Service Letter: No. 336

Subject: Bell 412 Air Conditioner Hi/Lo Pressure Switch / Receiver Drier Schrader Valve Installation

Applicability: Bell Helicopter Model 412

Reference: F.A.A. / S.T.C. SR00066DE
Drawing # 412AC-100, 412AC-102

Fig 1-1, View Looking Inboard From Aircraft Right.

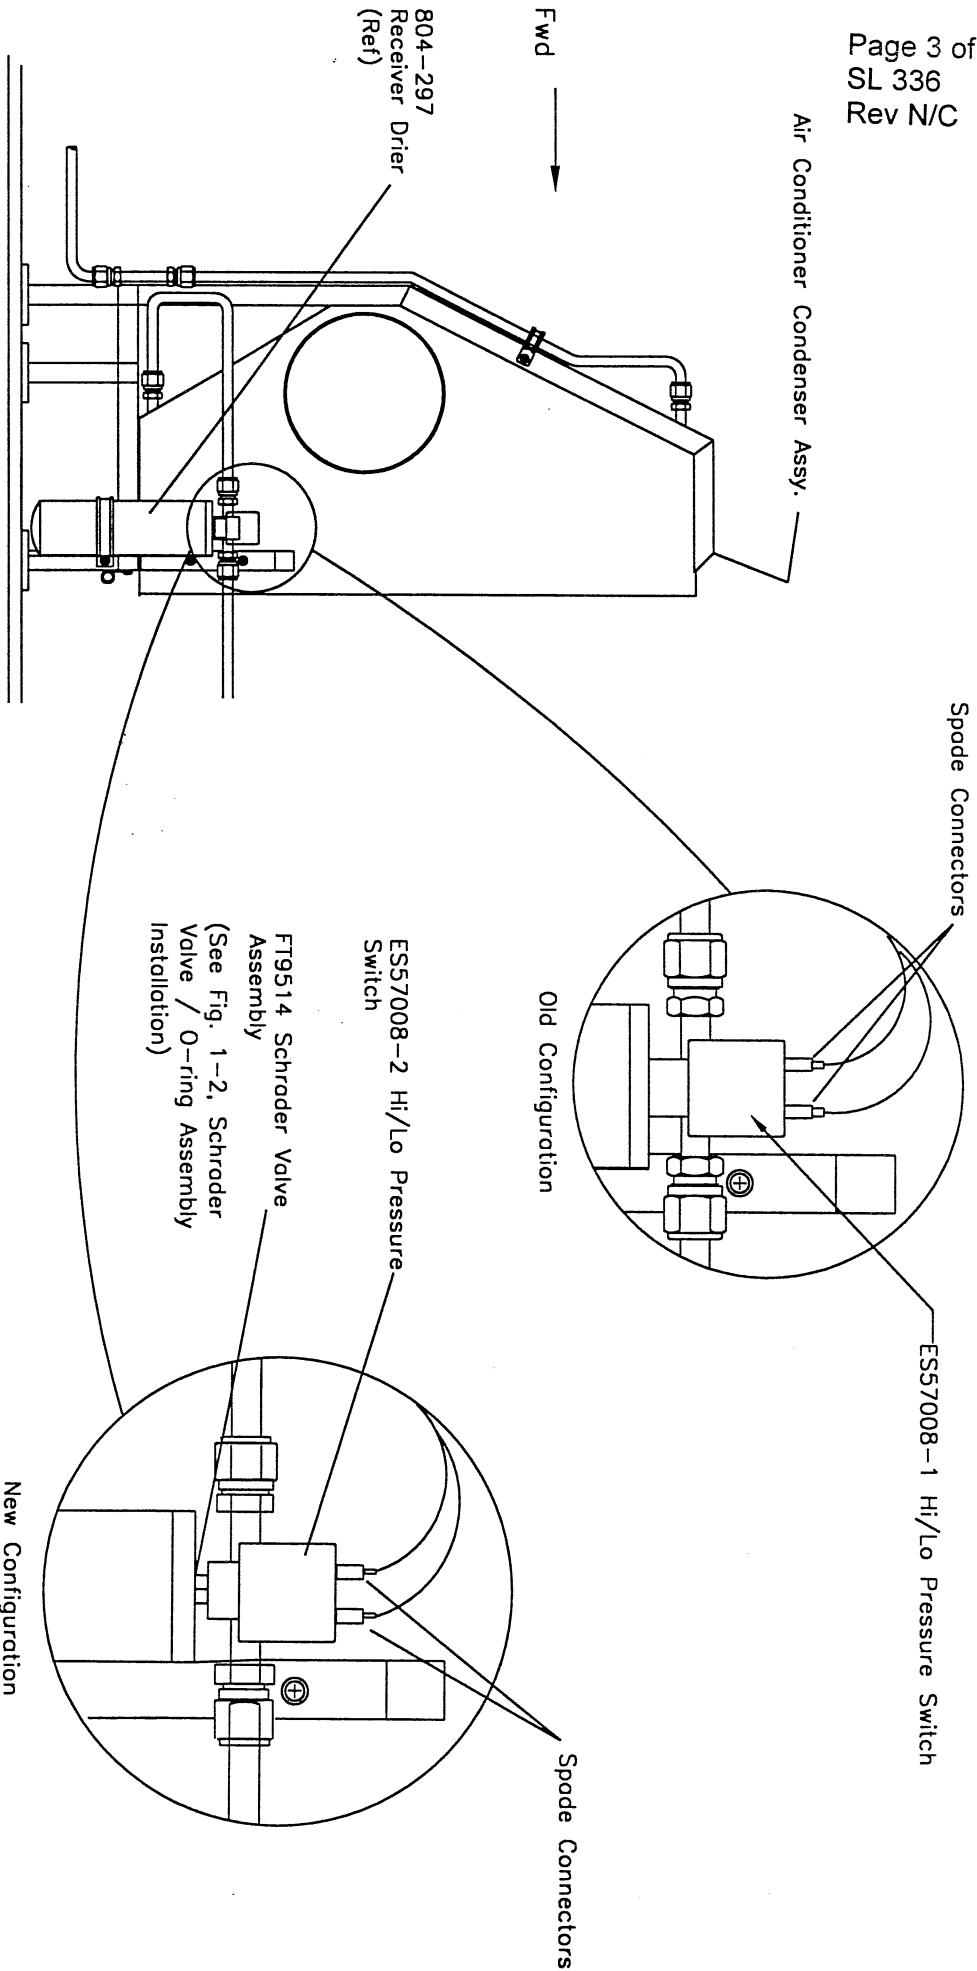
3. Remove the two (2) spade connectors from the top of the ES57008-1 Hi/Lo Pressure Switch. (See Fig. 1-1)

2. Install the new ES57008-2 Hi/Lo Pressure Switch on the Schrader Valve assembly, and torque 30-40 in lbs.
3. Re-install the two (2) spade connectors to the top of the ES57008-2 Hi/Lo Pressure Switch. (See Fig. 1-1)
4. Re-service the air conditioner with R134a refrigerant per Servicing Instructions in applicable service manual (412AC-200M, 412AC-203M, 412AC-206M, or 412AC-208M).
5. Conduct leak check using a R134a compatible electronic leak detector to insure there are no refrigerant leaks associated with this change.

Fig. 1-2, Schrader Valve / O-ring
Assembly Installation

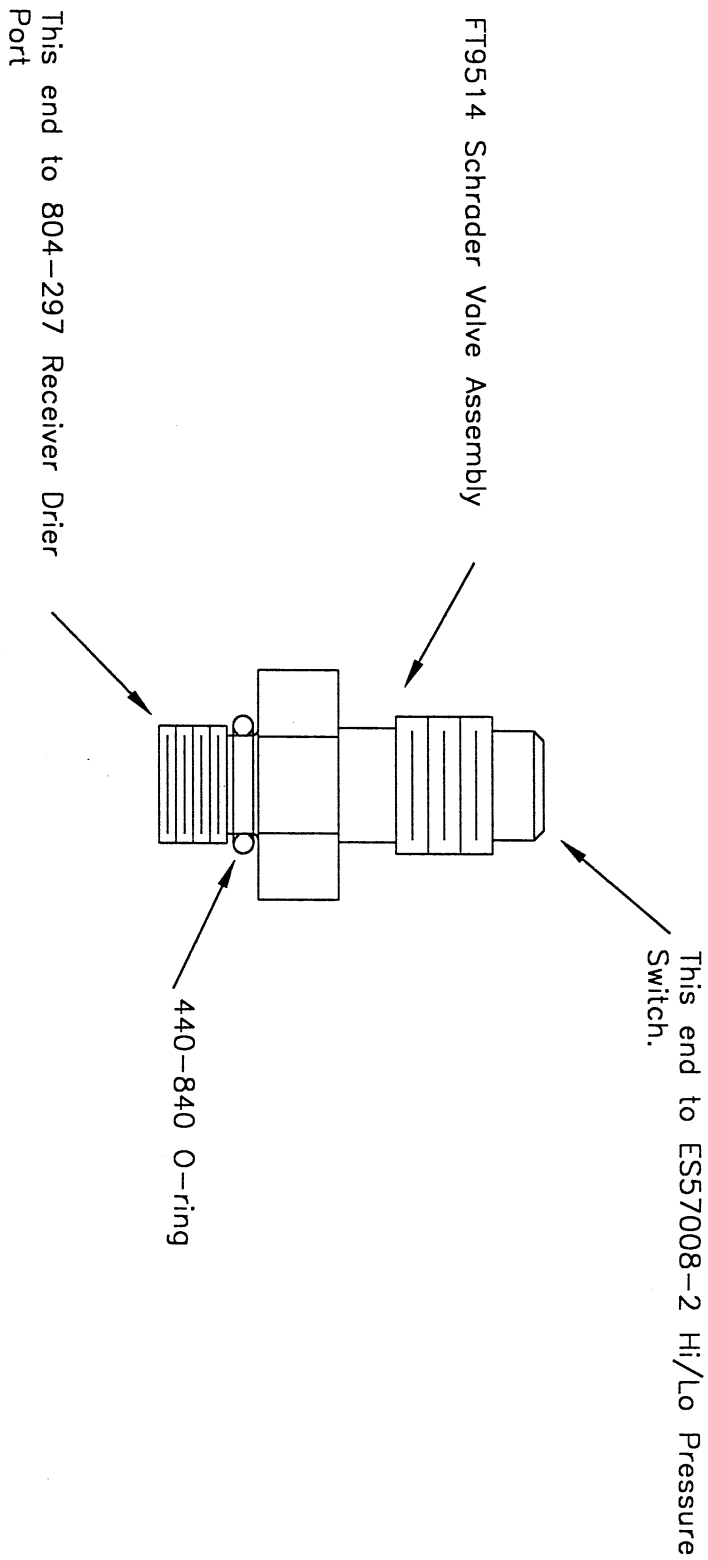
1. Install one (1) each 440-840 #6 O-ring & FT9514 Schrader Valve assembly in the port located on the top of the receiver drier bottle. Torque Schrader Valve assembly 40-55 in lbs. (See Fig. 1-2)

Place one drop of polyester based R134a refrigerant oil on the O-ring prior to installation. This will aid in preventing damage to the O-ring surface during installation.
